# NORTH TEXAS MUNICIPAL WATER DISTRICT

## LAKE SIDE INTERCEPTOR REPLACEMENT

PROJECT NO. SRWWPCF 07-1(102)

### CONFORMED SET

**PLAN AND PROFILE**  
 STA. 3+54.39 TO STA. 4+00

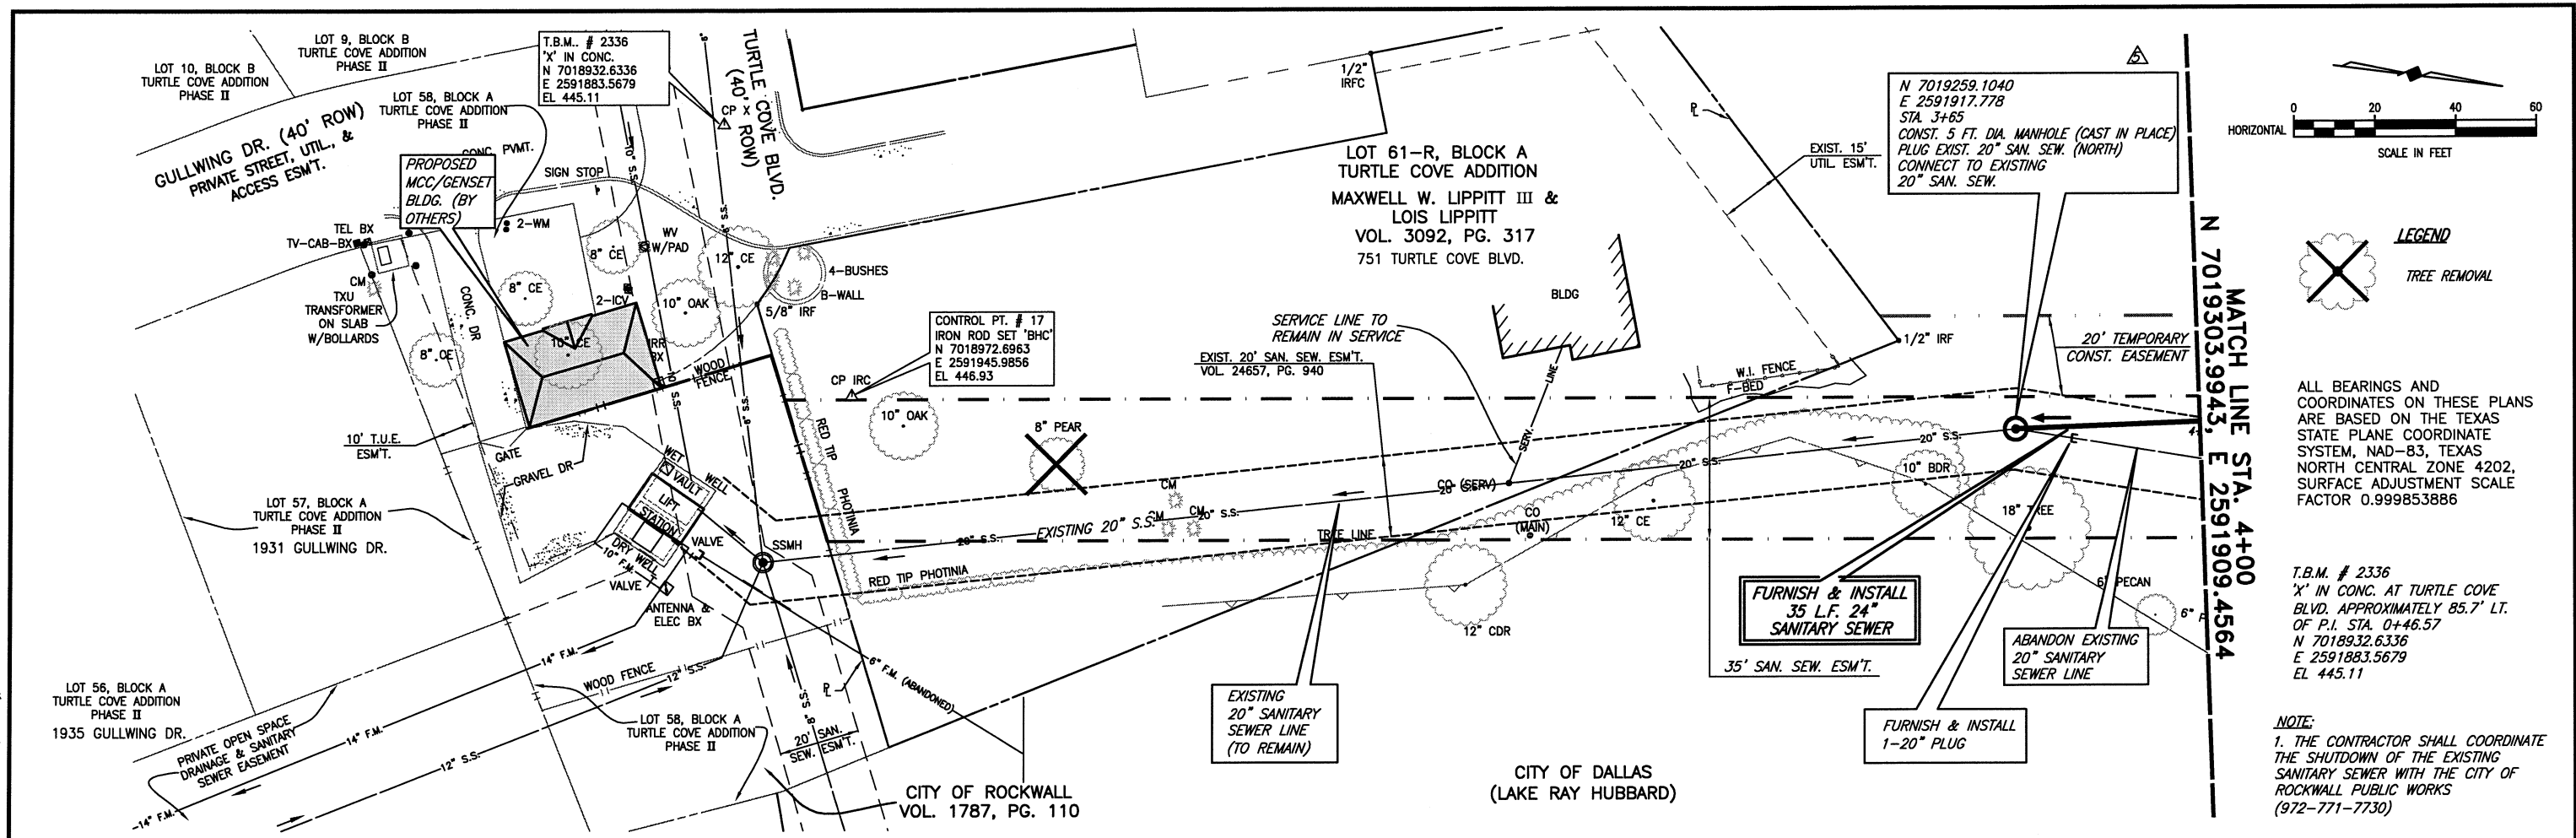
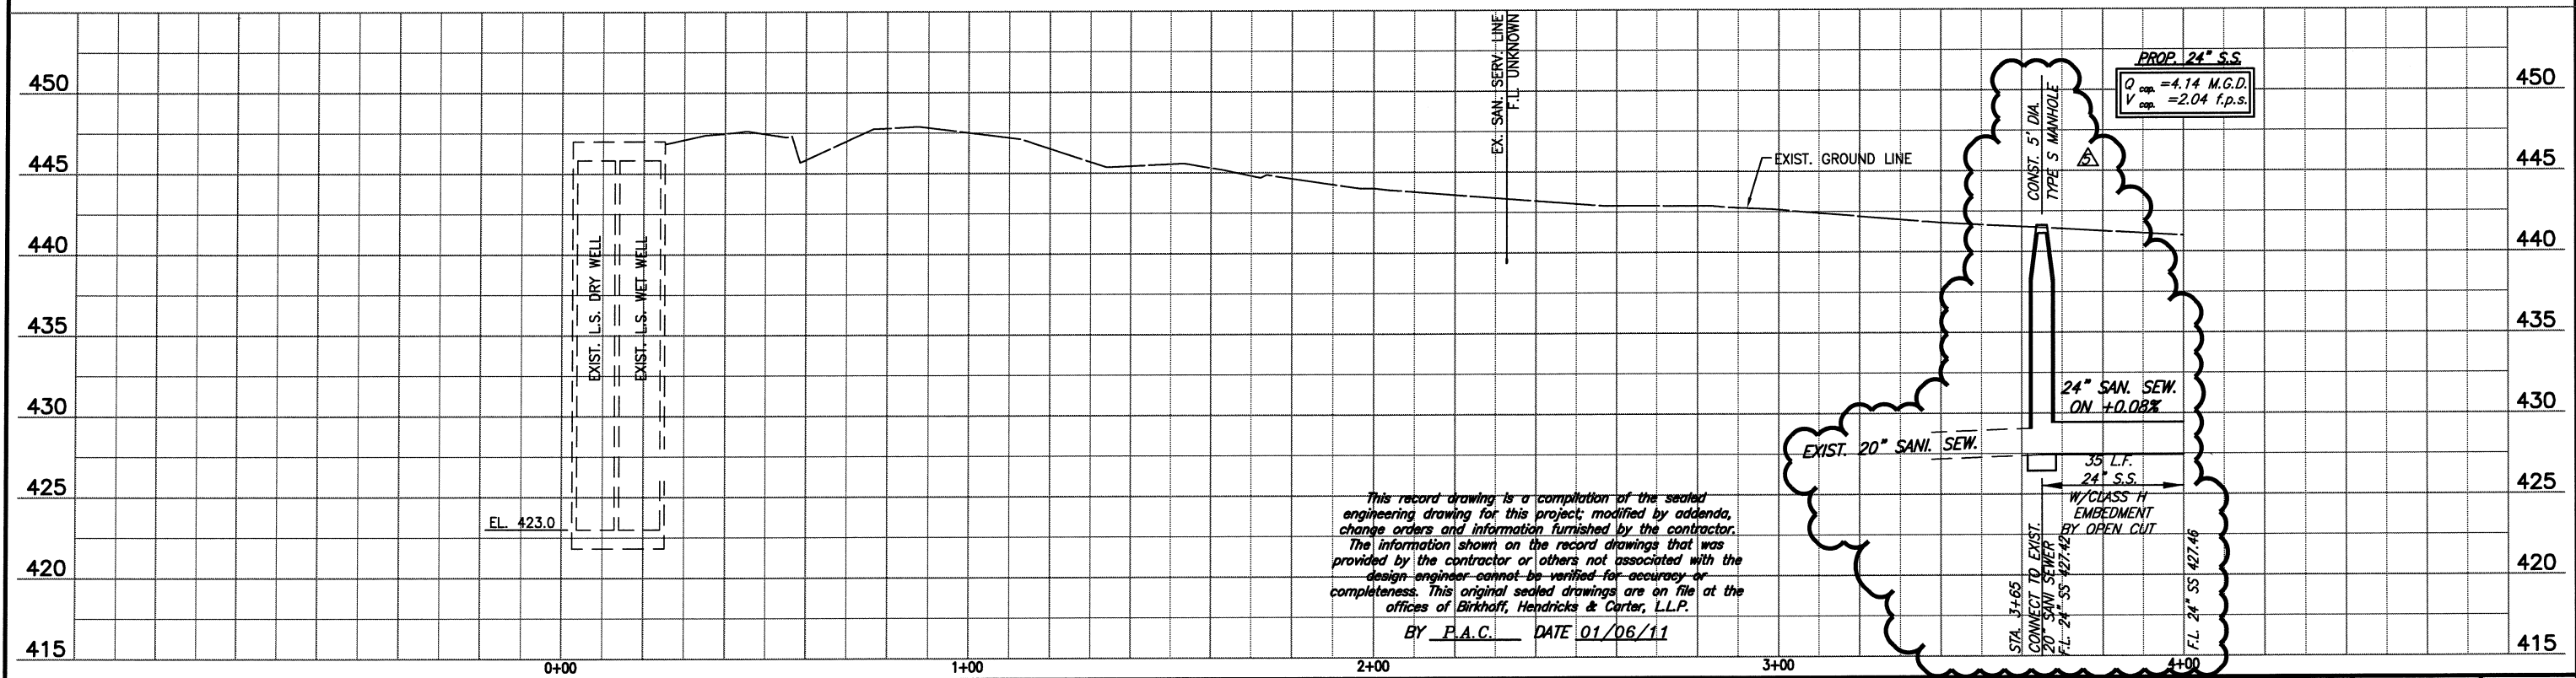
▲	FIELD CHANGE NO.1	1/14/09	- PIPE INSTALLATION METHOD REVISED (STA. 2+52 TO STA. 3+52)
▲	FIELD CHANGE NO.2	2/12/09	- REVISED TREE REMOVAL LOCATIONS
①	CHANGE ORDER NO.1	2/12/09	- REVISED BORE LOCATIONS & ENCASEMENT
▲	FIELD CHANGE NO.3	5/04/09	- REVISED CONNECTION AT WET WELL
▲	FIELD CHANGE NO.4	6/29/09	- REVISED VERTICAL ALIGNMENT
▲	FIELD CHANGE NO.5	6/11/10	- CAST IN PLACE MANHOLE

**PLAN AND PROFILE**  
STA. 4+00 TO STA. 9+00

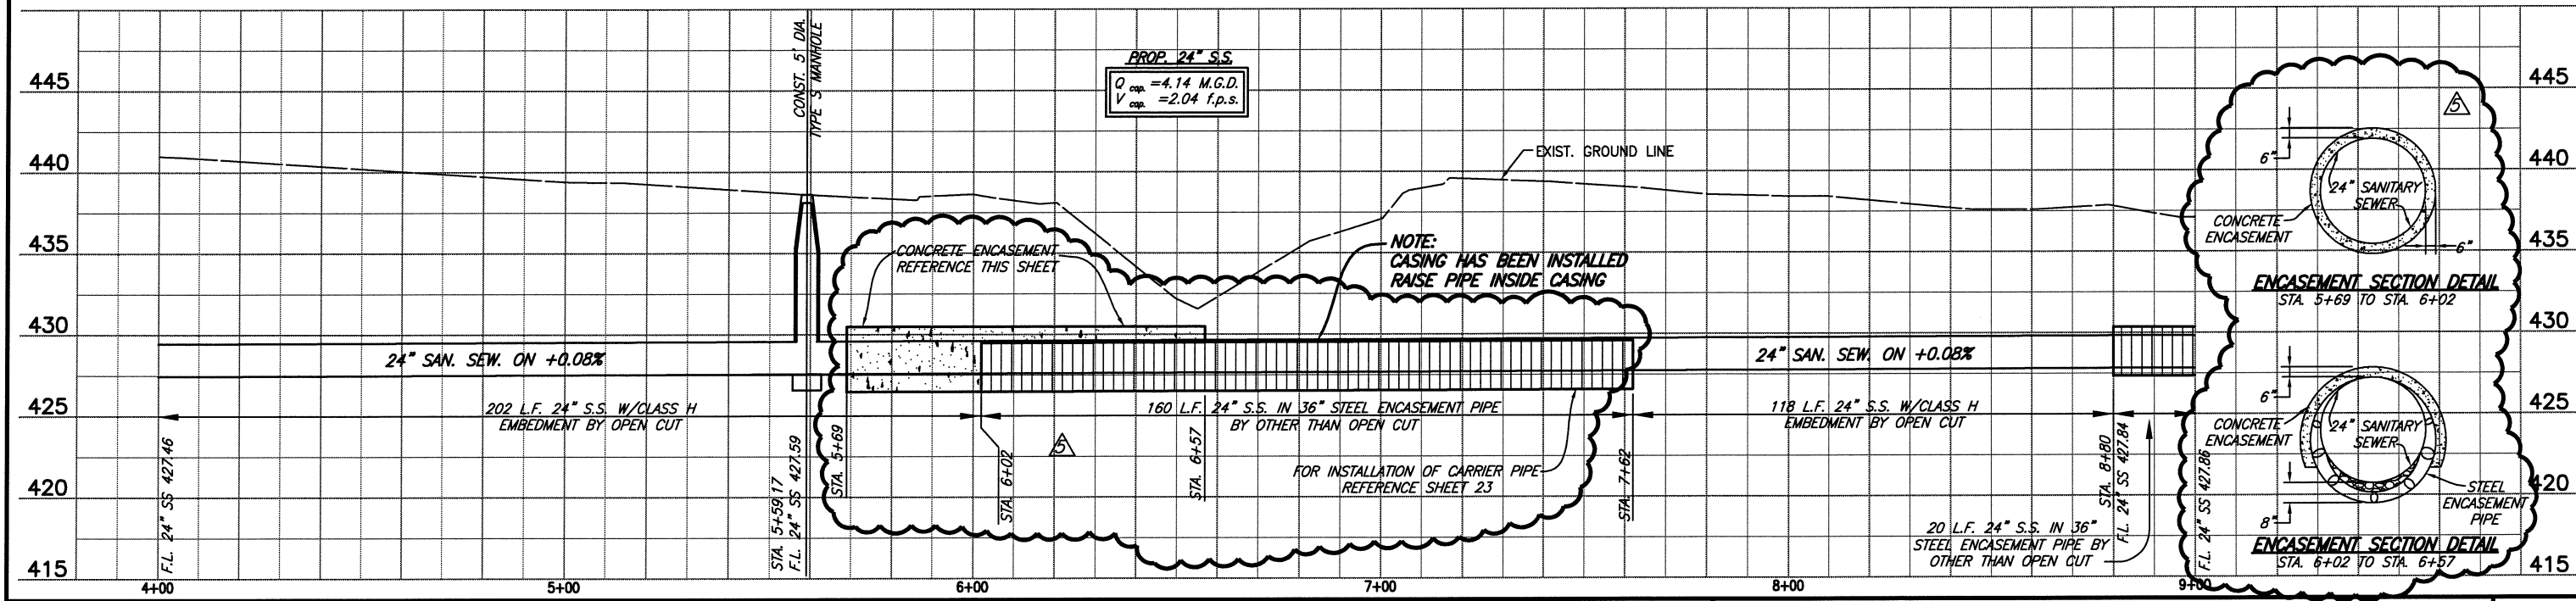
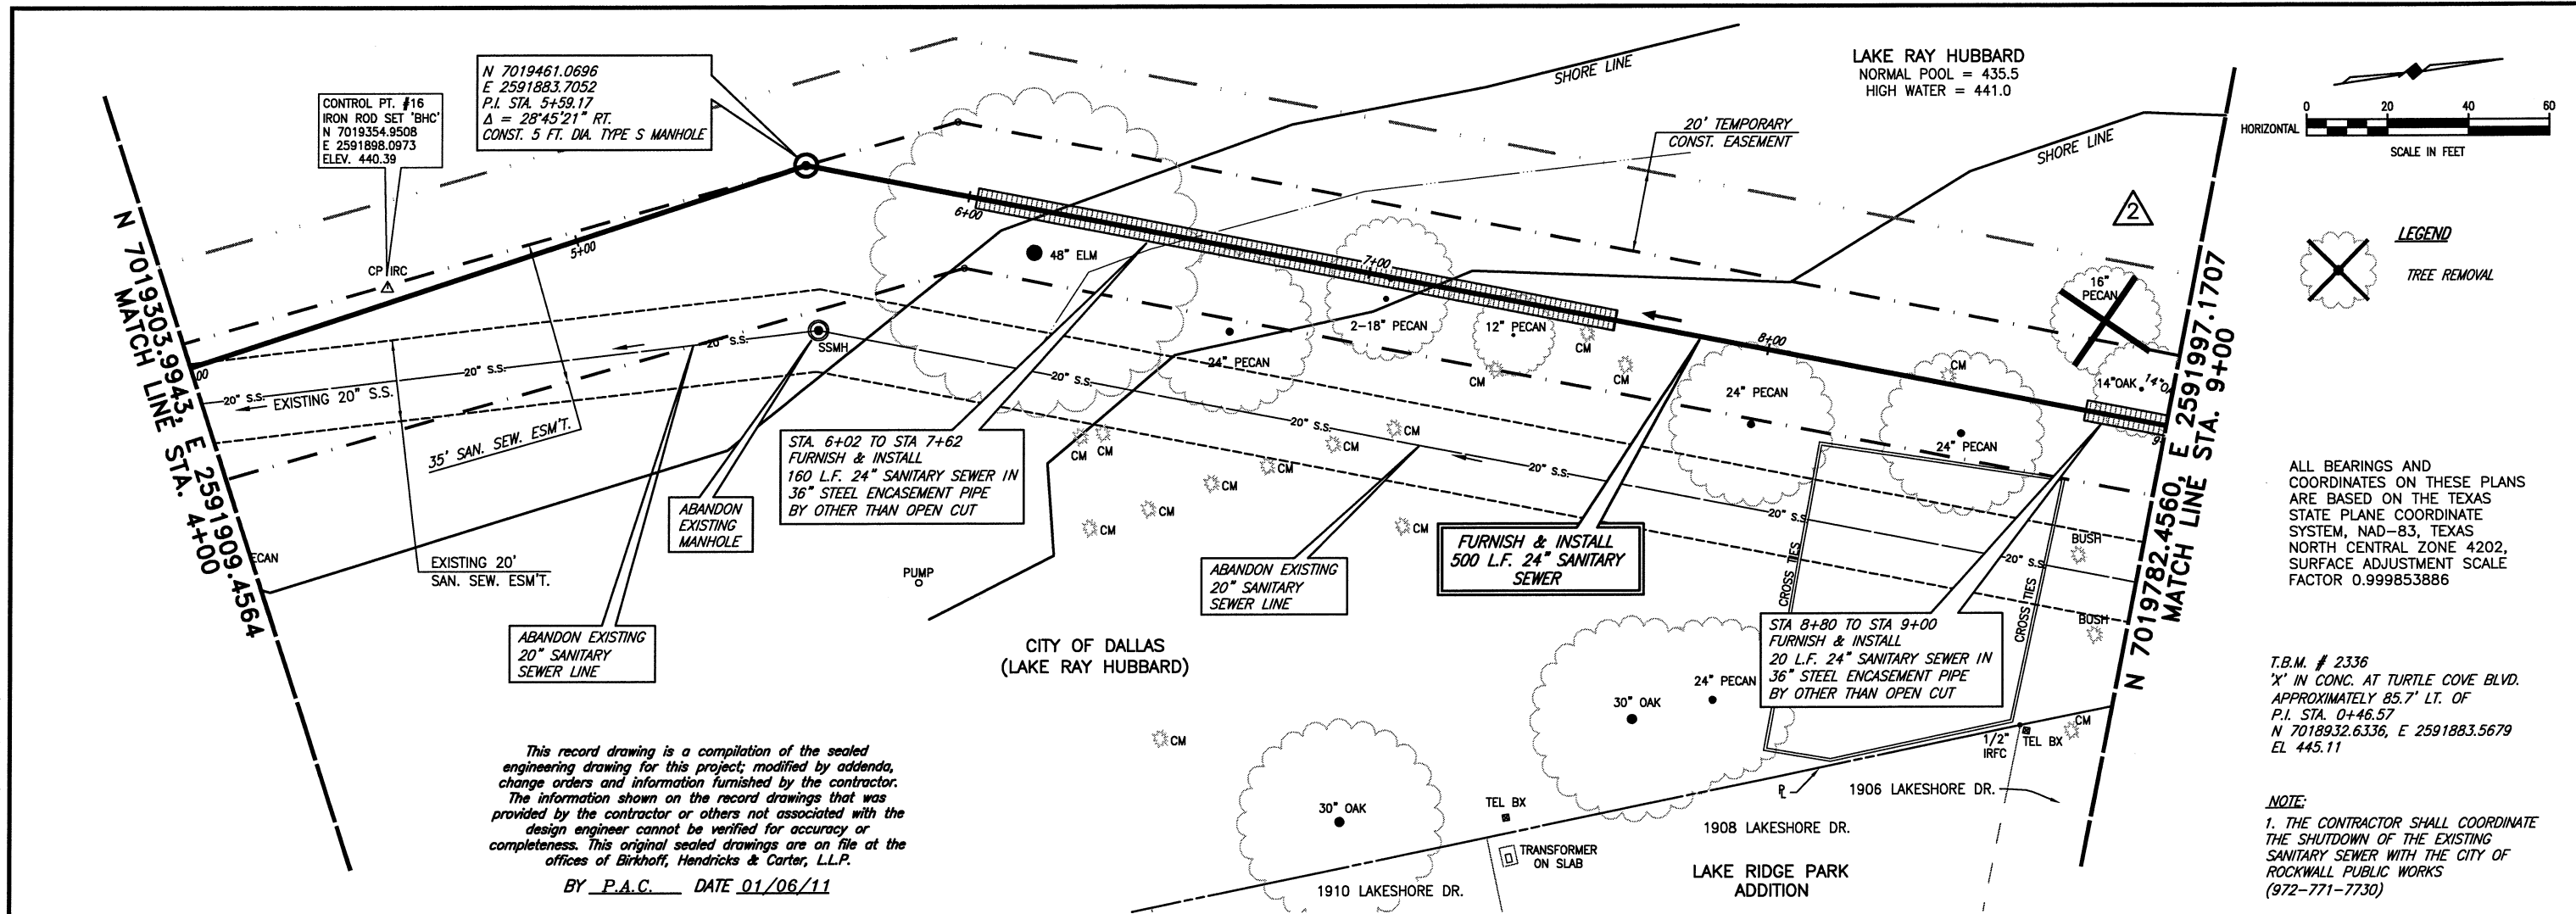
△	FIELD CHANGE NO.2	2/12/09	- REVISED TREE REMOVAL LOCATIONS
①	CHANGE ORDER NO.1	2/12/09	- REVISED BORE LOCATIONS & ENCASEMENT
△	FIELD CHANGE NO.4	6/29/09	- REVISED VERTICAL ALIGNMENT
△	FIELD CHANGE NO.5	11/07/09	- PER INSTALLATION
